Economic Commission for Europe**Inland Transport Committee****World Forum for Harmonization of Vehicle Regulations****187th session**

1958 Agreement:**Consideration of draft amendments to existing****UN Regulations submitted by GRBP****Proposal for Supplement 7 to 03 series of amendments to UN
Regulation No. 51 (Noise of M and N categories of vehicles)****Submitted by the Working Party on Noise and Tyres***

"Figure 4c
**Flowchart for vehicles tested according to paragraph 3.1.2.1. of Annex 3 to this Regulation –
 Gear selection using locked gear PART 2**

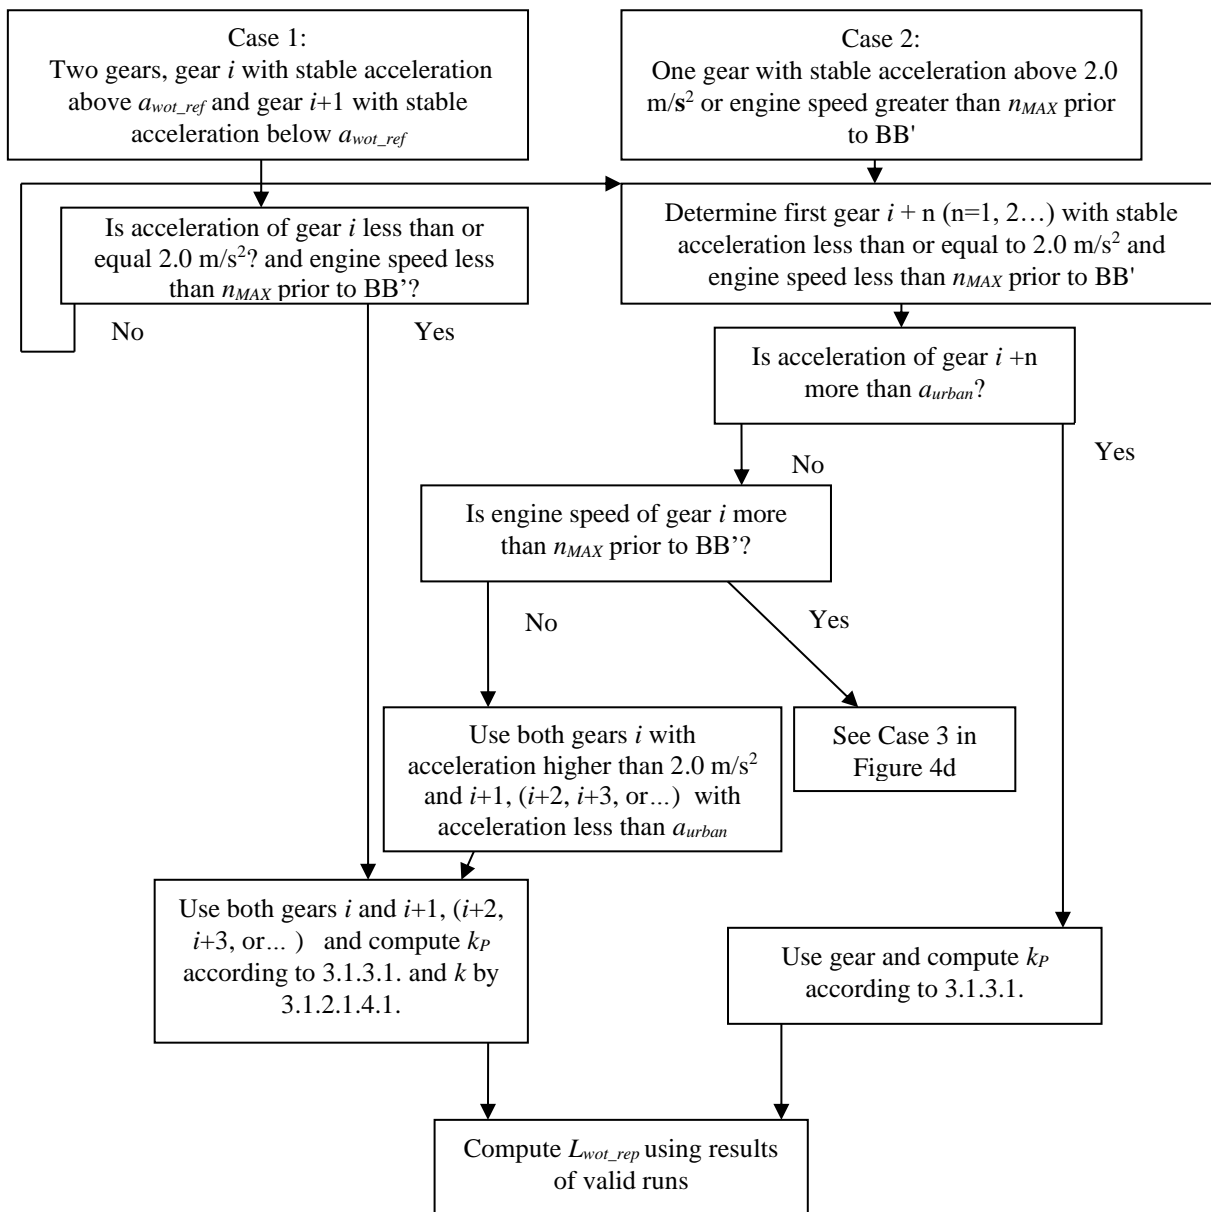
Annex 3 – Appendix 1 (renumbered), Figure 4c, amend to read:

"Figure 4d

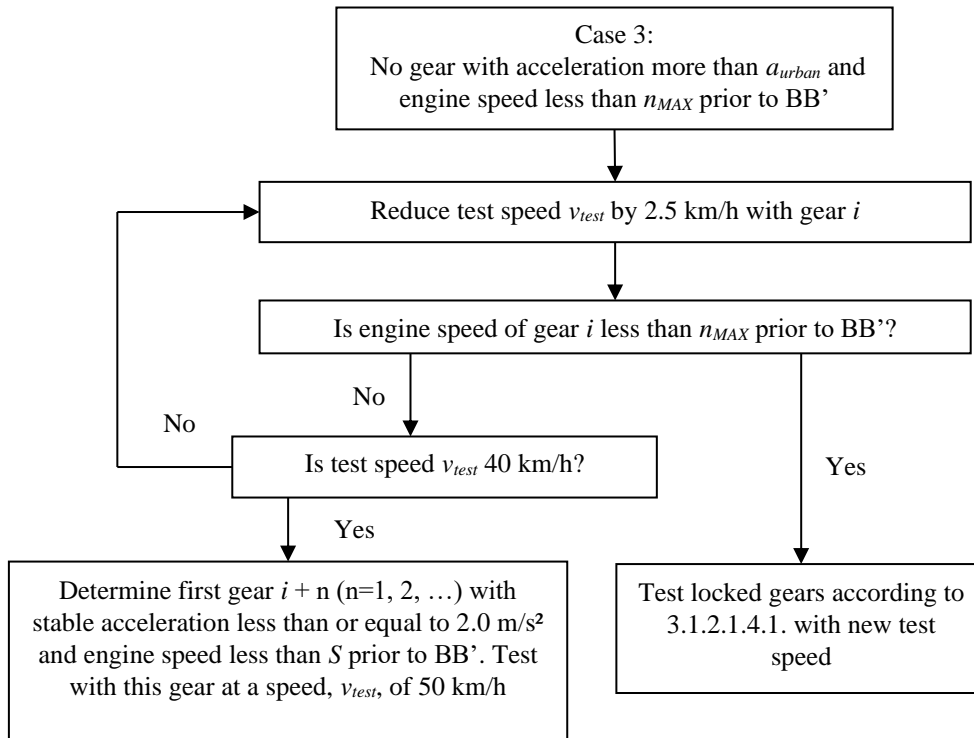
Annex 3 – Appendix 1 (renumbered), Figure 4d, amend to read:

"Figure 4e
Flowchart for vehicles tested according to paragraph 3.1.2.1. of Annex 3 to this Regulation –
Gear Selection using non-locked gears

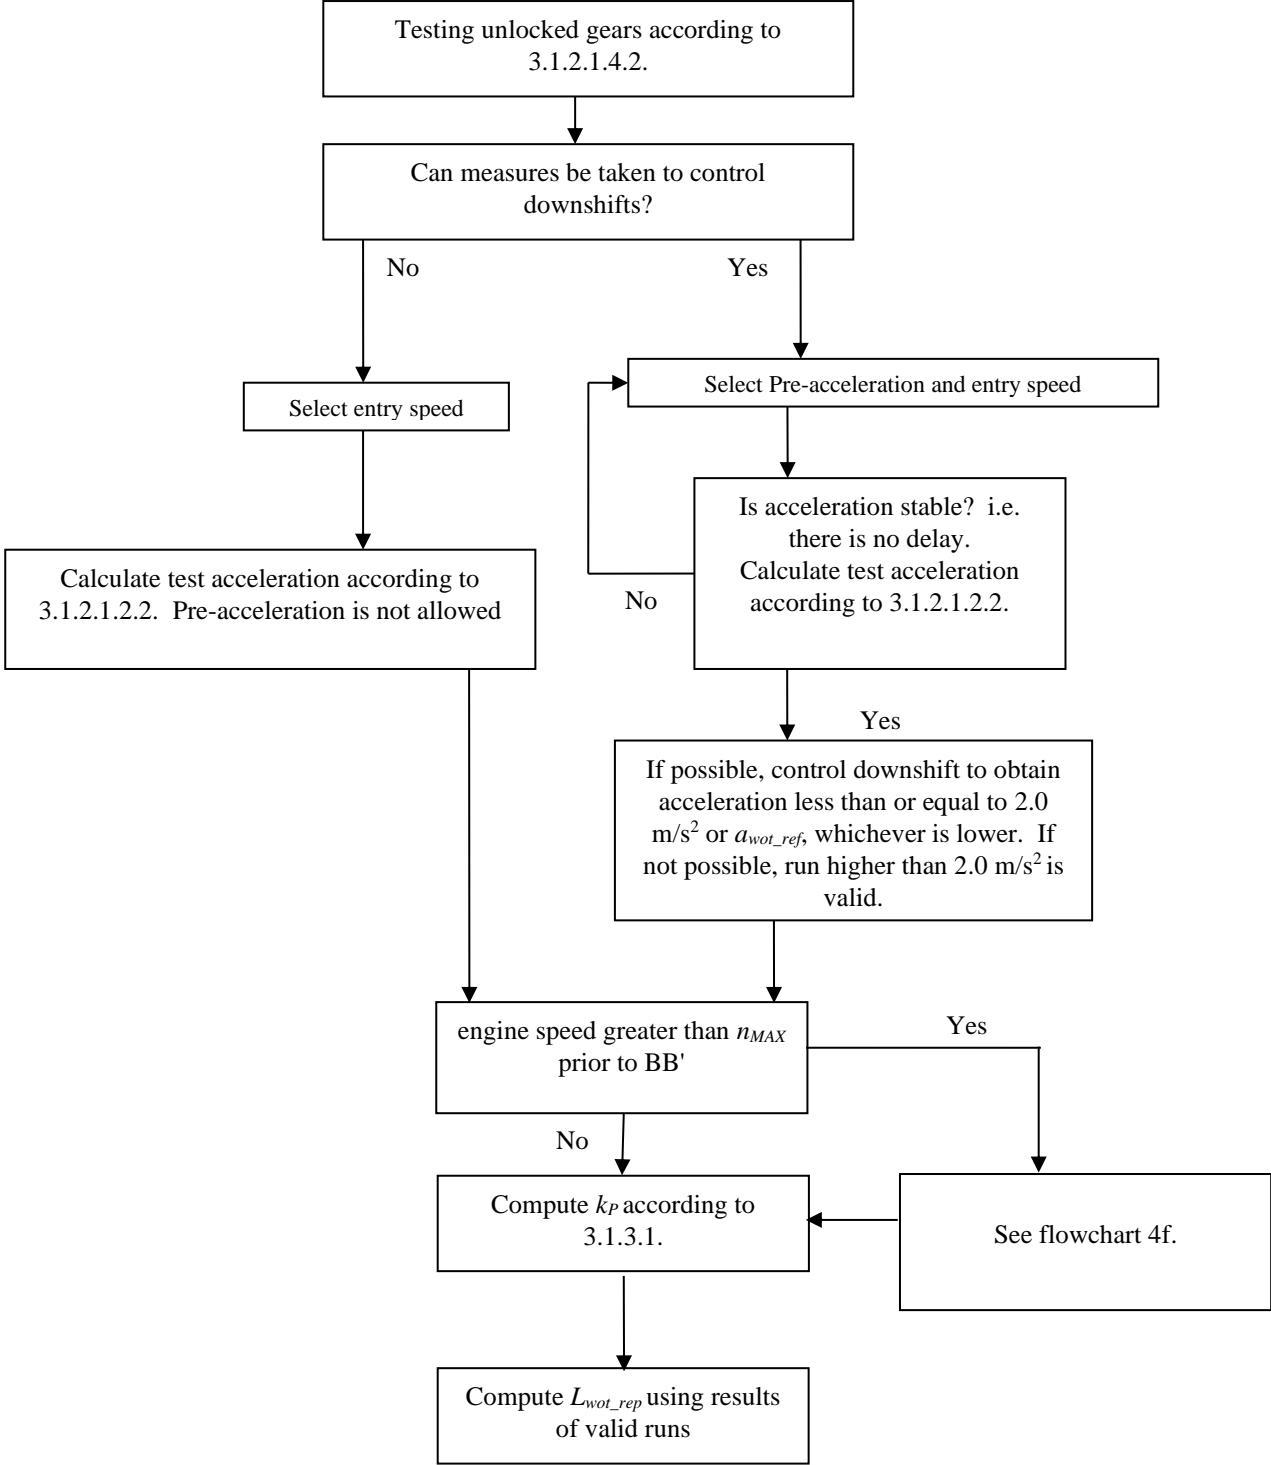
Annex 3 – Appendix 1 (renumbered), Figure 4e, amend to read:

"Figure 4f

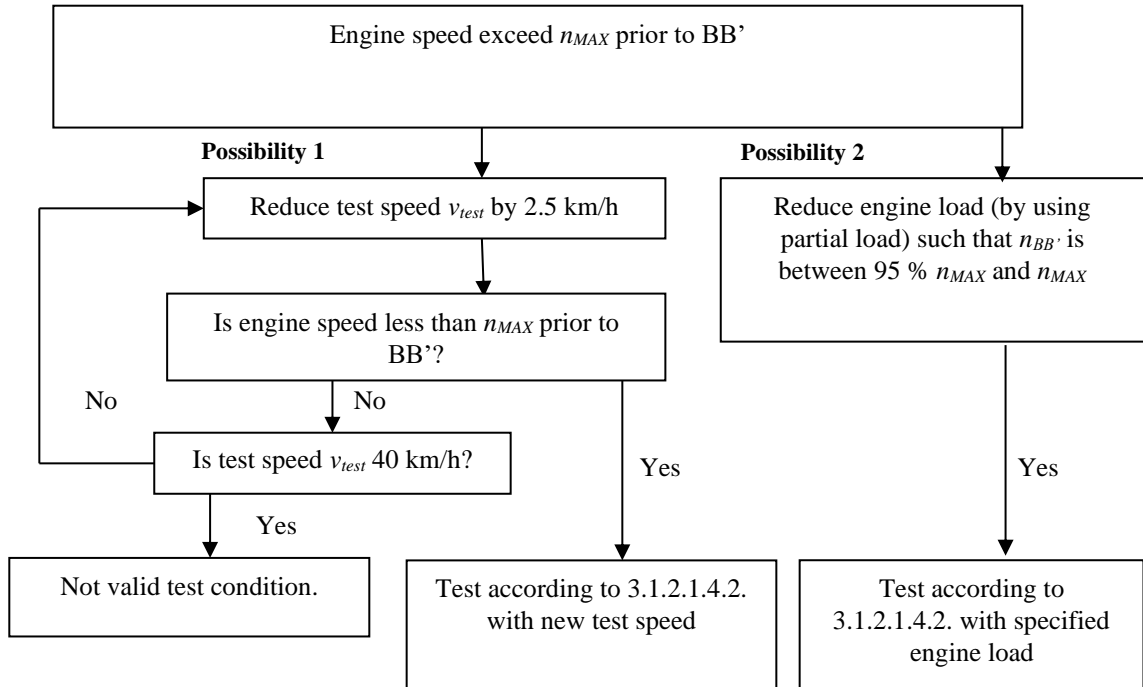
Annex 3 – Appendix 1 (renumbered), add a new Figure 4f, to read:

Figure 7a
Flowchart for vehicles tested according to paragraph 3.1.2.1. of Annex 3 to this Regulation – Correction of pass-by measurements for temperature and if applicable for test track differences

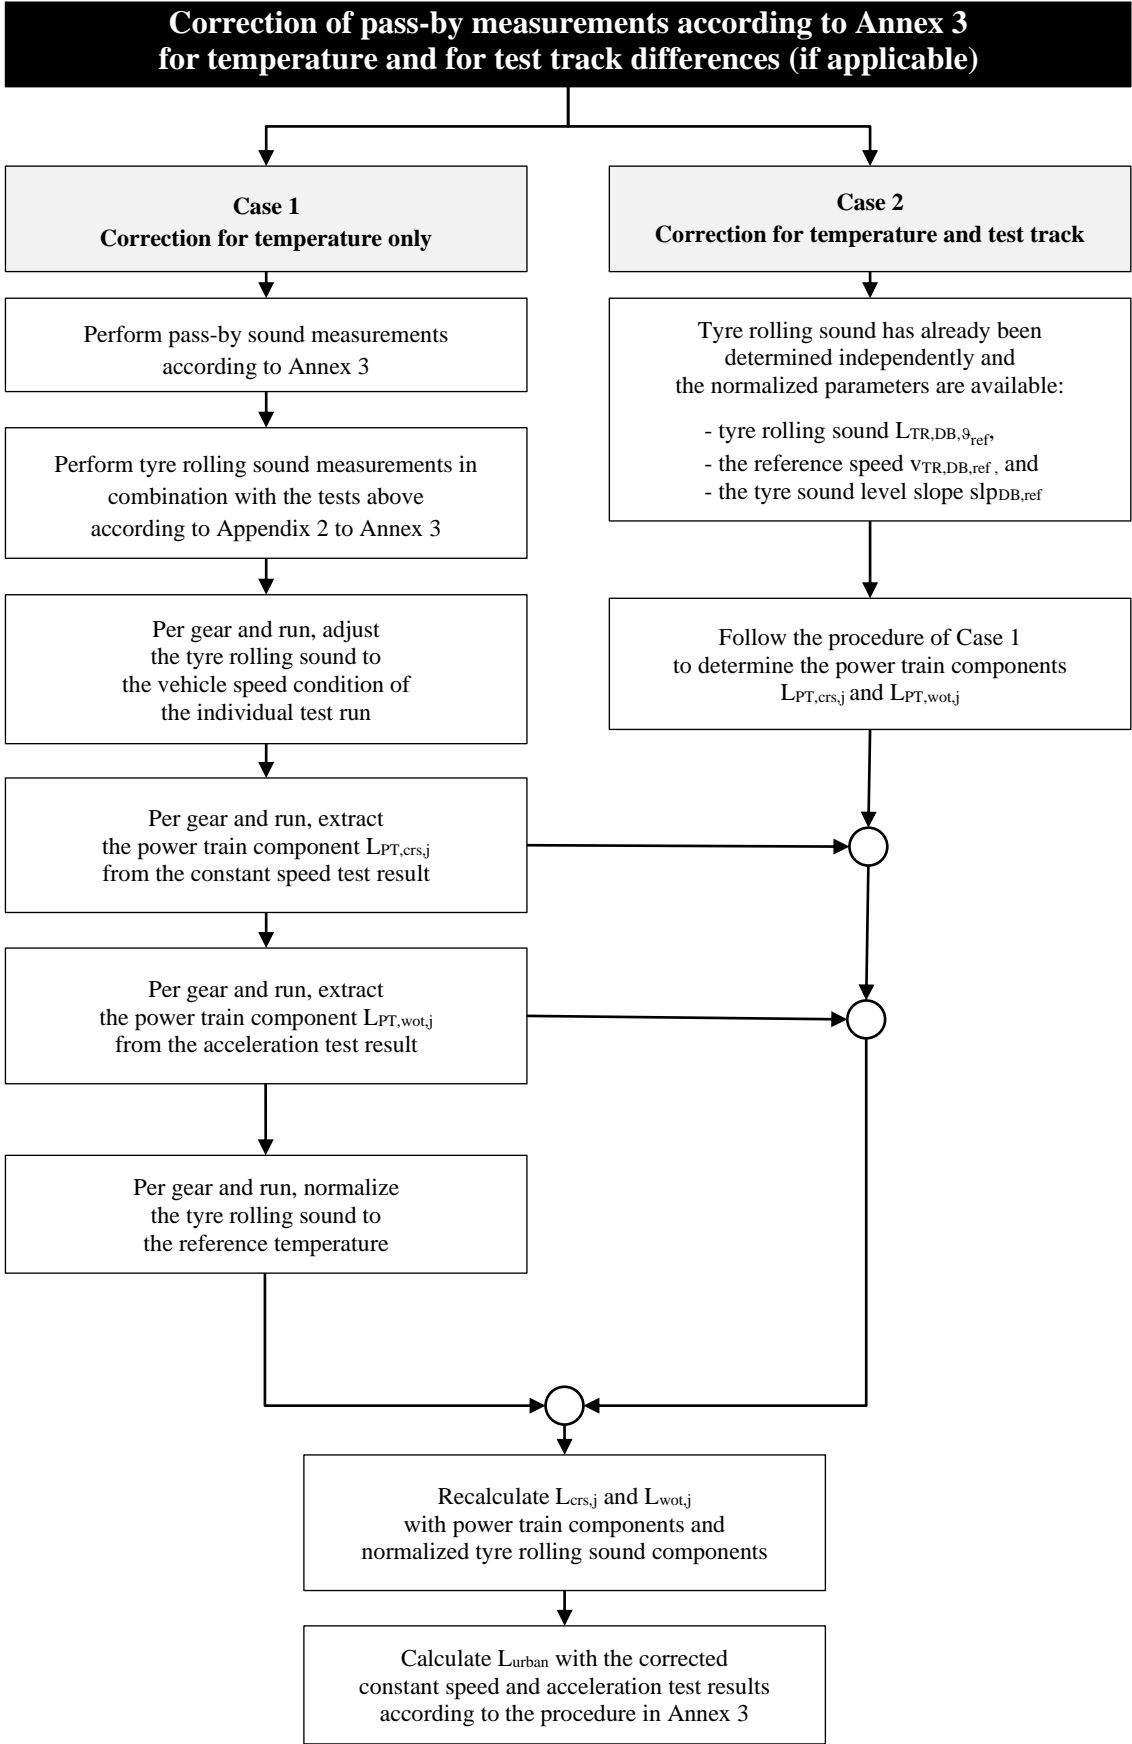
Annex 3, add a new Appendix 2 to read:
